Project	IEEE 802.16 Broadband Wireless Access Working Group < http://ieee802.org/16 >	
Title	Short Data Burst Support for MSS in Sleep Mode	
Date Submitted	2004-08-30	
Source(s)	Hang Zhang, Mo-Han Fong, Peiying Zhu, Wen Tong Nortel Networks	mhfong@nortelnetworks.com Voice: +1-613-765-8983 Fax: +1-613-765-6717
	Yigal Eliaspur Penny Efraim Sagi Sharon Ben-Porath David Ayoun Intel Cooperation	Yigal.eliaspur@intel.com Voice: +972-54-7884877
	Itzik Kitroser Runcom Technologies	itzikk@runcom.co.il
	Yong Chang Samsung Electronics	yongchang@samsung.com
	Philip Barber Broadband Mobile Technologies, Inc.	pbarber@BroadbandMobileTech.com
Re:	IEEE P802.16e/D4-2004	
Abstract	This contribution proposes to support short data burst transmissions to/from MSS in Sleep Mode	
Purpose	Review and Adopt the suggested changes into P802.16e/D4	
Notice	This document has been prepared to assist IEEE 802.16. It is offered as a basis for discussion and is not binding on the contributing individual(s) or organization(s). The material in this document is subject to change in form and content after further study. The contributor(s) reserve(s) the right to add, amend or withdraw material contained herein.

Fig. 1. Current operation for a small amount of DL data transmission to an MSS in Sleep Mode.

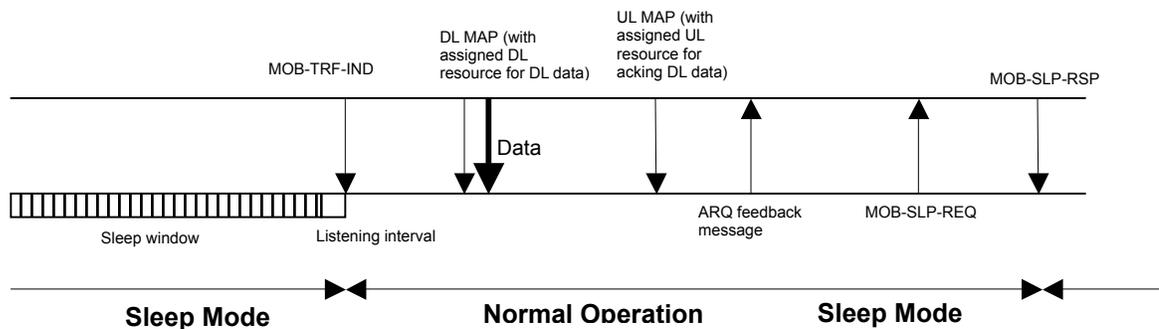
In p802.16e/D4, the Sleep Mode is introduced in Section 6.3.19 for the purpose of power efficient operation. Based on the current standard, any UL/DL traffic transmission will result in a mode transition from Sleep Mode back to Normal Operation. Switching back to Sleep Mode involves some overhead (SLP-REQ – SLP-RSP transactions, see figure 1 below). This overhead spoils the efficiency of the Sleep Mode mechanism.

Fig. 2. DL data burst transmission to an MSS in Sleep Mode during SDB Window.

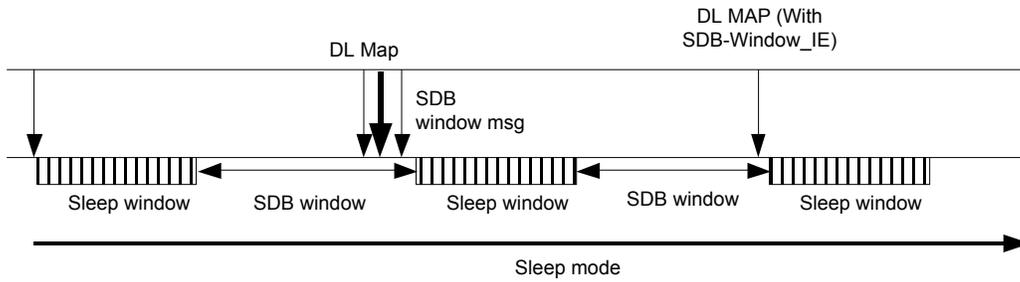
- SDB Window:
 - Scheduled Data Burst (SDB) Window is a period (defined in full frames), in which MSS should be listening for DL bursts (unicast/multicast/broadcasts) and look for UL allocations.

- First frame of next SDB Window for a specific CID is defined using SDB-Offset IE in DL-MAP.
 - During SDB Duration MSS will remain awake and listen for DL traffic and UL allocations. MSS will resume sleep (SDB-Offset termination) after receiving a new SDB-Offset IE. Sleep will be resumed in the following frame.

- In frames with broadcast DL traffic, BS may use SDB-Offset, in order not to impose on the DL-MAP with the IE.
 - For each CID there may be only one pending SDB-Offset. A new SDB-Offset IE for a specific CID replaces any previous SDB-Offset defined for this CID.

- See figure 2.
- SDB Offset Information Element (SDB-Offset IE):
 - BS may include in the DL-MAP this information element, which includes offsets to the first frame of next SDB Window for various CID (for unicast, multicast and broadcast).

Fig. 3. DL data burst transmission to an MSS in Sleep Mode during Listening Interval.

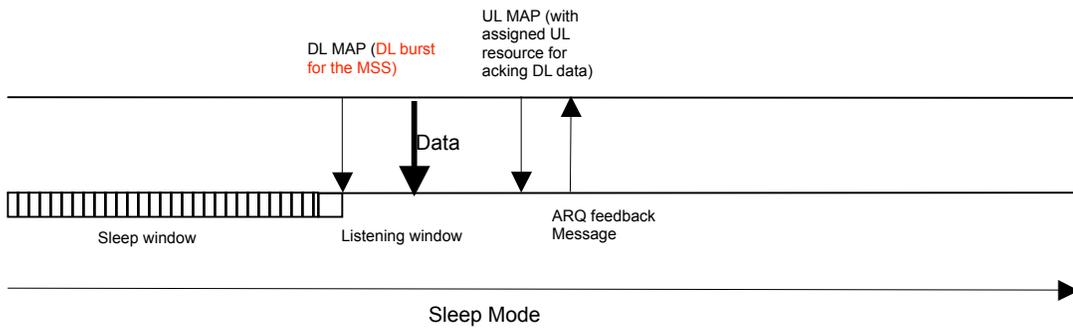
- BS may transmit short bursts of data during the Listening Interval
 - MSS is required to process DL-MAP and the corresponding DL burst allocation, during the whole Listening Interval, and look for DL bursts which are targeted to it.
 - If ARQ is in use, MSS will remain awake, even if the Listening Interval is over, until it finished receiving all the blocks (and ACKing them), or until ARQ timeouts expire.
 - See figure 3.

Fig. 4. UL data burst transmission from an MSS in Sleep Mode.

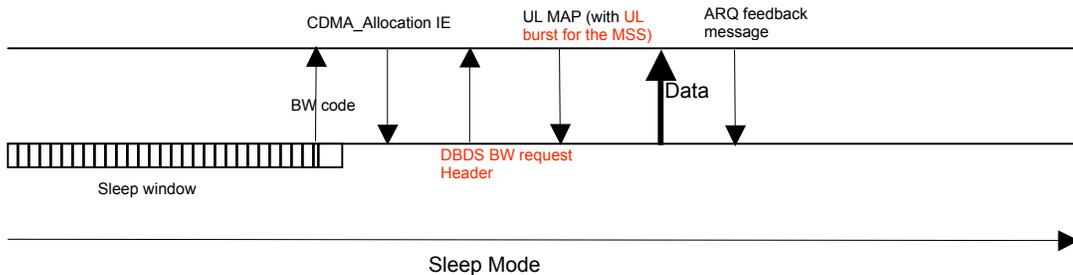
- Data Burst During Sleep BW Request (DBDS-BW-REQ):
 - Add a new type of BW-REQ, which means MSS has UL data to transmit (typically a small amount), and requires BW allocation to do so, without terminating Sleep Mode.
 - When BS receives a DBDS-BW-REQ it allocates UL allocations to the MSS, but the MSS is still considered to be in Sleep Mode (PDUs are buffered by BS etc.)
 - See figure 4.

Fig. 5. DL/UL data burst transmissions to/from an MSS in Sleep Mode, for UGS connection.

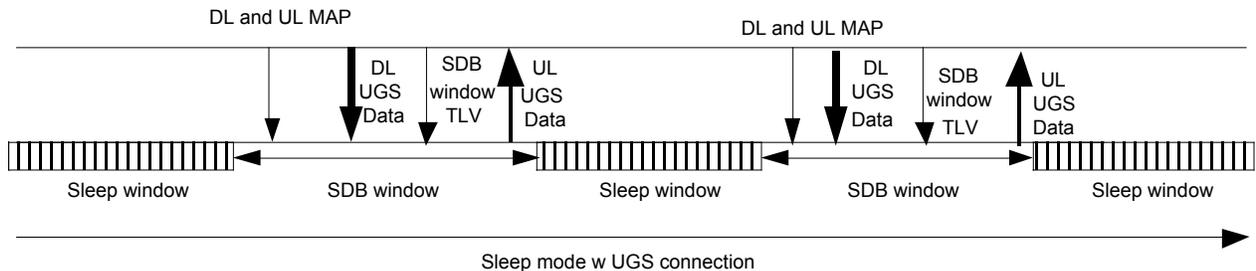
- UGS/rtPS/nrtPS connections and Sleep Mode:
 - Existing connections will maintain their states and parameters when MSS goes to Sleep Mode.
 - BS may maintain and keep providing to MSS periodic UL allocations for such connections.
 - BS may use SDB Windows to schedule DL transmissions and UL allocations for such connections.

- MSS may power down / sleep until SDB Window, and then awake, receive DL transmissions and use UL allocations for UL traffic.
- If ARQ is in use, MSS will remain awake, and keep transmitting until all blocks are ACKed or max number of retries was reached.
- DL/UL transmissions to MSS on such connections should be done during SDB Windows, but may also be done during Listening Intervals.
- SDB Window scheduling can be used for connections of MSSs that are not in Sleep Mode. Such an MSS may be able to identify opportunities to power down, during periods that no connection has scheduled traffic, to save power.
- See figure 5 for UGS example

Fig. 6. Sleep Mode termination, initiated by MSS

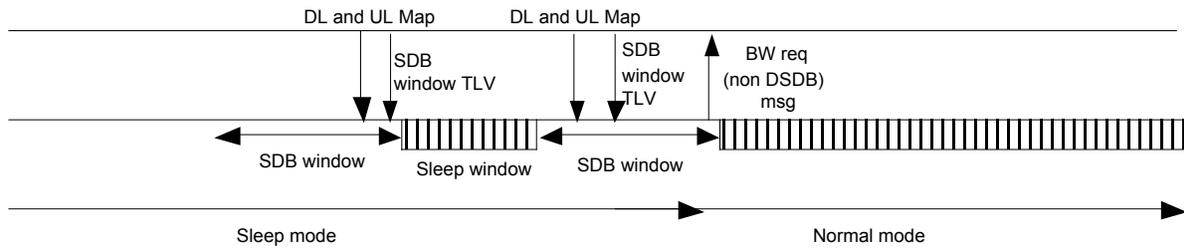
- Redefinition of Sleep Mode termination:
 - Sleep Mode will be terminated by MSS initiative only when BS receives a standard (non-DBDS) BW-REQ from MSS.

- See figure 6 for Sleep Mode termination by MSS initiative.
 - Sleep Mode will be terminated by BS initiative only when MSS receives a positive traffic indication in MOB-TRF-IND message (pending traffic indication and not Ranging opportunity).

Fig. 7. Sleep Mode termination, initiated by BS

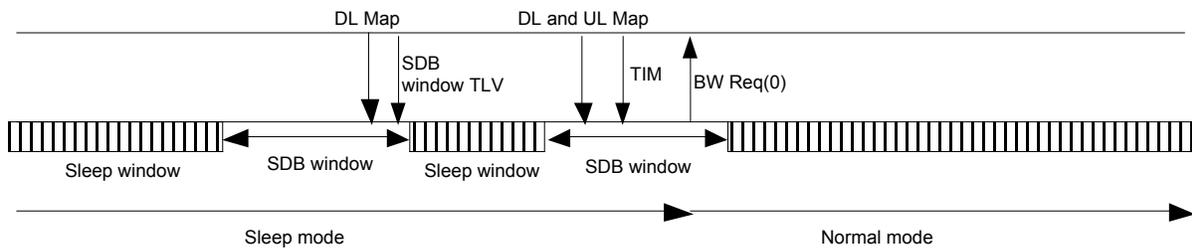
- Even after sending positive traffic indication, BS will assume MSS is still in Sleep Mode (and not send the pending data) until receiving a standard (non-DBDS) BW-REQ from the MSS, as an acknowledgment to the MOB-TRF-IND.

- For any other type of PDU sent by MSS on UL or by BS on DL, Sleep Mode will be maintained.
 - See figure 7 for Sleep Mode termination by BS initiative.
